DETAIL DESIGN ROAD SAFETY AUDIT
SH1 WAIKATO EXPRESSWAY 110 KM/H SPEED
REVIEW PROJECT TAMAHERE

PREPARED FOR WAKA KOTAHI NZ TRANSPORT AGENCY

26 October 2021

Figure 4: Roadside barriers across gully (Google, 2021)

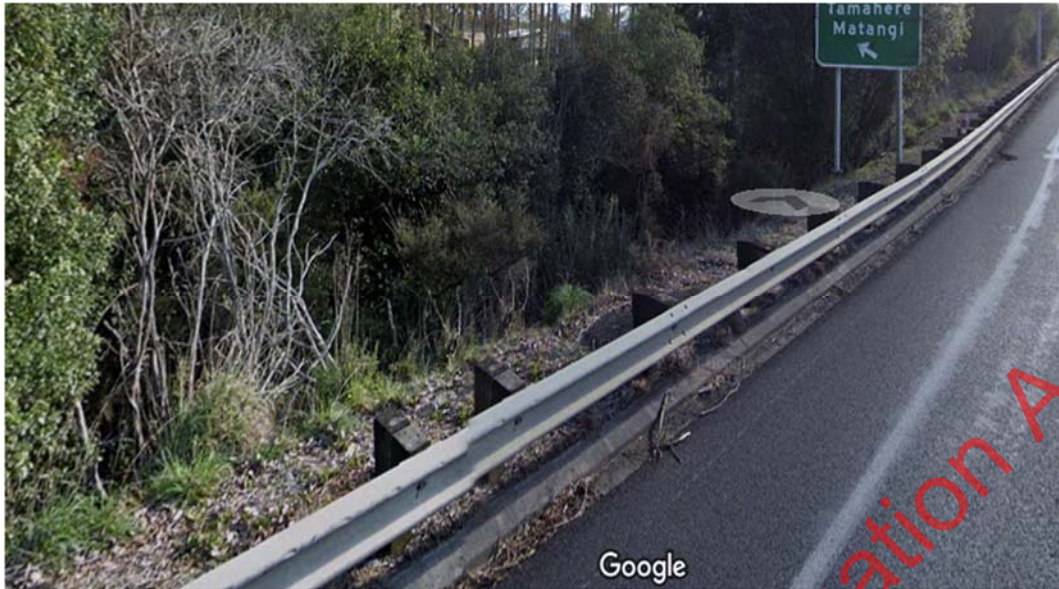
Although the barriers appear not to have received any recent strikes (as would be evidenced by replaced sections of barrier) their performance in preventing a vehicle (especially a high centre of gravity vehicle) from crossing the median into opposing traffic or crashing into the gully or road below may be questionable. The main concern is their low mounting height in relation to the road surface, particularly on the interchange bridge.

1. Replace the existing median and roadside barriers (and especially the bridge barriers) with a taller and more appropriate level of performance barrier system.

Frequency Crashes are likely to be infrequent	Severity Death or serious injury is likely	Rating The safety concern is moderate
Designer response	<p>Agree in general principles, though this is currently outside the scope of the work, and would require some specialist bridge input into the affixing replacement barriers to the bridge deck. We have sourced plans of the original bridge, and preliminary advice is that concrete barriers would not be able to be placed without considerable strengthening of the bridge, and semi-rigid TL4 barrier (eg thribeam) would be more likely to be the appropriate treatment.</p> <p>The replaced roadside barriers would be at the same offset from the edgeline, which is in the order of 2.0m – considerably less than the 3.0m RONS standard elsewhere on the Waikato Expressway.</p> <p>The median barrier currently existing with a 5.0m grassed median (with the exception of the bridge crossing itself), narrower than the desired minimum for wire rope barrier medians. It is noted that the Hamilton Section terminates with a double sided F shape concrete barrier TL4 height. A suitable treatment would likely be a double sided semi rigid barrier until the median widens to the existing</p>

Safety Engineer comment	<p>Designer response is acknowledged. It is recommended to the client that all barriers including interchange bridge barrier be replaced thereby providing safety to road users.</p>	
Client decision	<p>This work is beyond the original scope of works and requires review. If mitigation of the existing risk is required, impact on the WEX 110km/h project (schedule, time, cost) to be approved and funding allocated.</p>	
Action taken	<p>A scope change request has been developed identifying the risk with the performance of the existing barriers and potential mitigation options. Date of resolution tbc.</p>

Figure 5: Flexible to semi-rigid barrier transition detail

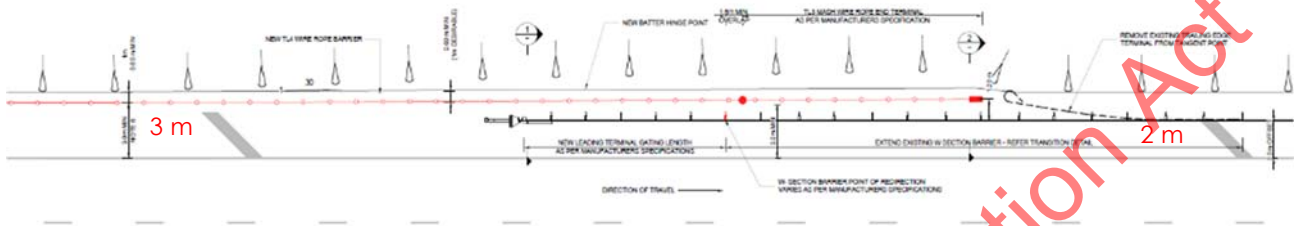
The transition from flexible to semi-rigid barrier, which would be applied only near the northbound exit ramp, shows a 1 m lateral step from the widened shoulder width of 3 m to tie into an existing shoulder width of 2 m.

Normally the projected faces of the flexible barrier and the semi-rigid barrier would line up, i.e. be the same offset from the edge line, and the flexible barrier would deviate behind the semi-rigid barrier only locally.

Although the proposed detail appears to adopt the same performance principles as shown in the RSB7A standard drawing of Waka Kotahi, it may be worth checking that Waka Kotahi is comfortable with the proposed detail.

Designer response	Accepted. Propose to use a flared guardrail extension and terminal to widen to 3.0m rather than a lateral step. Detail updated.
Safety Engineer comment	Agree with designer's response.
Client decision	Agree with SAT and RSE
Action taken	The design has been updated to reflect the designers response.

Figure 8: Proposed barriers along northbound entrance ramp

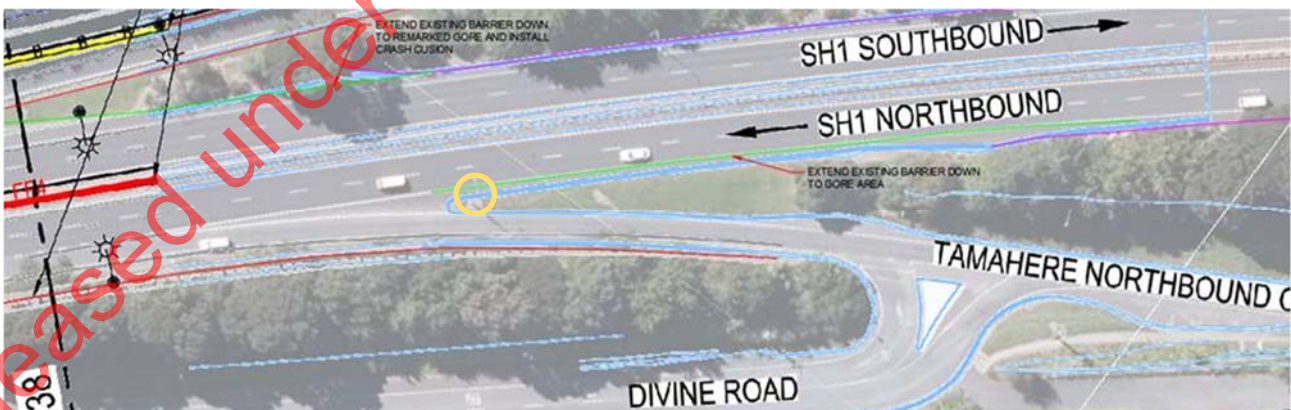
The designers are contemplating providing barriers along the left-hand side of the entrance ramp as shown in red in Figure 8 and Figure 9 and extending the existing barriers to the nose as indicated by the green line in Figure 8 and Figure 9. The southern end of the flexible barrier system already installed on the Hamilton Bypass project is shown by the yellow arrow in Figure 9.

The proposal would be a positive safety improvement as there are a number of large trees and a lighting column next to the ramp.

Refer to Section 2.1.7 concerning the proximity of the lighting column in Figure 8 (yellow circle) and Figure 9 to the proposed barrier next to the expressway.

Figure 10: Proposed barriers along southbound exit ramp

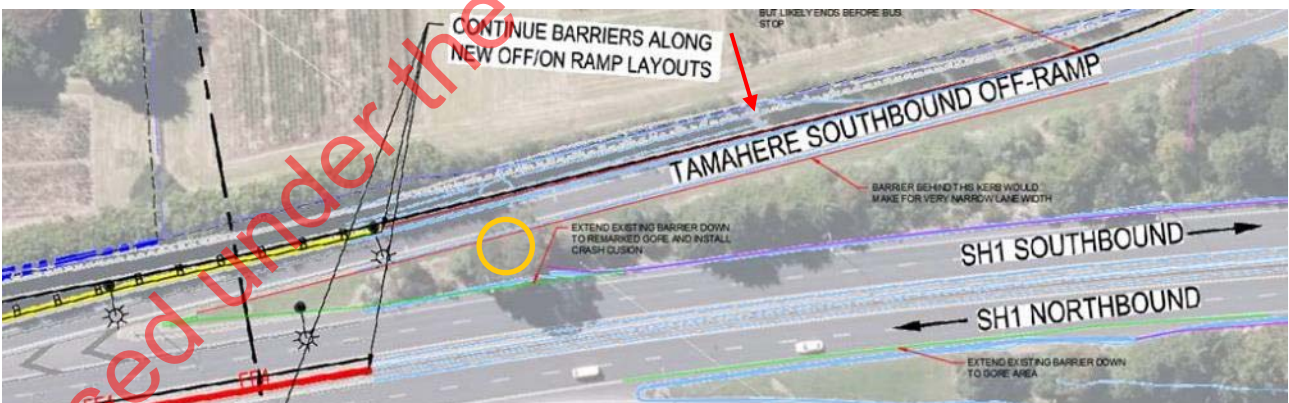
The designers are contemplating providing barriers along both sides of the entrance ramp as shown in red in Figure 10 and extending the existing barriers to the nose as indicated by the green line in Figure 10.

However, the designers expressed concern that installing barriers along the exiting edge of seal on both sides of the ramp would not provide enough width (5 m to 5.5 m) for broken down vehicles to stop or for emergency vehicles to pass without significant widening of the pavement.

The barriers on both sides of the ramp probably do not need to be extended as far down the ramp as proposed. There is a farm gate about halfway down the ramp, to which access would need to be maintained. The barriers could probably end at the gate. The ramp is straight and has good sight distance along it. Speeds would be bleeding off as drivers slowed for the ramp terminal intersection. The greatest risk of a crash would be close to the nose where drivers might suddenly realize that they have reached the exit and swerve across the gore losing control and crashing into the trees on either side of the ramp.

If the decision to provide barriers or not is to be based on the need to widen the ramp, then it is suggested that the left-hand barriers rather be set back beyond the existing kerbs close to the fence line than be omitted. If the barriers were set back sufficiently from the kerb, the kerb should not be a factor provided that the strip between the kerbs and the barrier were filled with hardfill. Again, it would be safer to provide the barriers and accept a slight risk of less than perfect barrier performance, than to omit the barriers.

Refer to Section 2.1.7 concerning the proximity of the lighting column in Figure 10 (yellow circle) and Figure 11 to the proposed barrier next to the expressway.

Figure 12: Proposed barriers along southbound entrance ramp

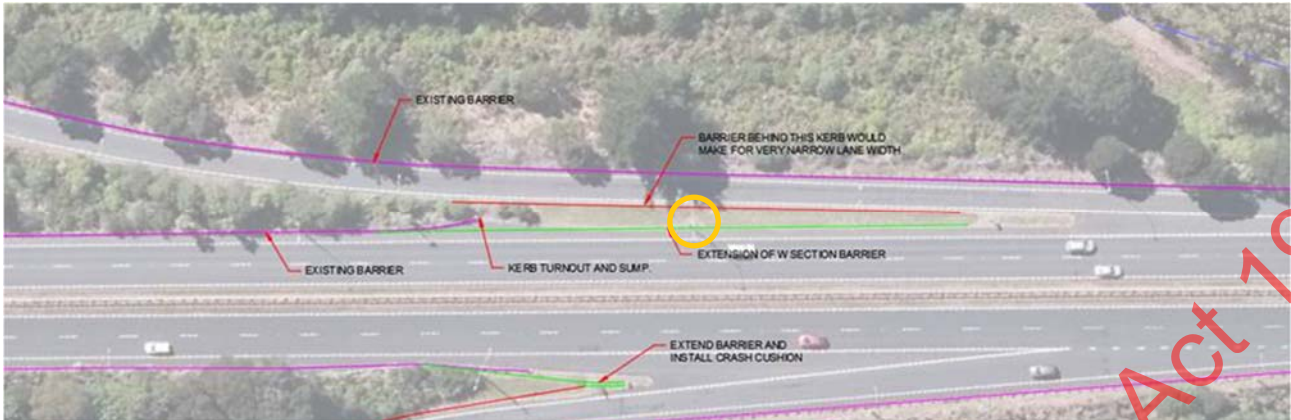
The designers are contemplating providing barriers along both sides of the entrance ramp as shown in red in Figure 12 and extending the existing barriers to the nose as indicated by the green line in Figure 12.

With the exception of the lighting column shown in Figure 13, there are no other significant hazards that motorists need to be protected from in the vicinity of the merge area.

The ramp joins the expressway as a standard entrance ramp merge so intervisibility between drivers entering the expressway and drivers using the expressway is a significant factor to be considered when placing the barriers in a position that could obstruct the intervisibility.

Refer to Section 2.1.7 concerning the proximity of the lighting column in Figure 12 (yellow circle) and Figure 13 to the proposed barrier next to the expressway.

Figure 15: Maintenance access bay detail

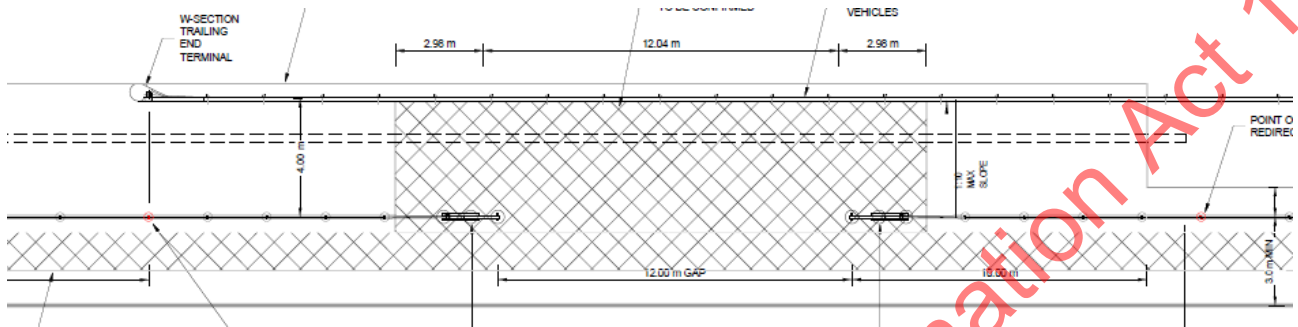
The proposed maintenance bays, which are intended to give access to the berm in both directions, are shown in Figure 15 and Figure 16. Although the detail shows a width of 4 m, the layout indicates 3 m.

The effective width of the maintenance bay in the detail in Figure 15 would be less than the 4 m width shown when the widths of the end terminals are taken into account. There is thus unlikely to be enough width for a maintenance truck to manoeuvre into the maintenance bay from the shoulder and a portion of the through lane will likely be required for the manoeuvre. Similarly, exiting the bay might require the front of the vehicle to swing wide into the adjacent lane. This would mean blocking the through lane while manoeuvring in or out, effectively bringing all traffic in that lane to an unexpected halt. This would be unsafe, not only for the general traffic, but also for the maintenance personnel.

The proposal to reduce the width to 3 m, due to space constraints, could render the maintenance bay almost unusable for any vehicle other than a ute.

1. Amend the design to a disengaging overlapping barrier layout that will allow maintenance vehicle drivers to pull over onto the shoulder first and then access the maintenance bay without encroaching into the adjacent through lane, while also fully shielding the maintenance vehicle and any personnel in the maintenance bay. This may require additional access bays or alternative arrangements to service the berm in both directions.

Frequency Crashes are likely to be infrequent	Severity Death or serious injury is likely	Rating The safety concern is moderate
Designer response	The current location shown is the widest location within the project length. Tracking paths with a 8m truck have been run on the current arrangement, which indicates that an additional 5m of length is required for the vehicle to make the entry. Also we acknowledge the difficulty exiting the vehicle, and have extended the paved area of the maintenance bay 12m beyond the rear barrier terminal to enable a vehicle to park clear of the barrier obstructing the doorway. Detail updated. An alternate arrangement to ensure that the appropriate TMP is followed is to remove the gap, and allow access into the bay area by means of a wire rope drop in conjunction with the lane drop. This would allow the rear barrier to be removed as well.	
Safety Engineer comment	Concern from SAT is noted, while it is preferable to have overlapping barriers, the option proposed by the designer also mitigates the risk highlighted by SAT. An alternate arrangement is not preferable. It is recommended to the client that the arrangement proposed by designer be opted.

Client decision	Agree with Designer and RSE.	
Action taken	The design has been amended to improve maintenance bay vehicle entry and personnel exiting the vehicle within the maintenance bay.
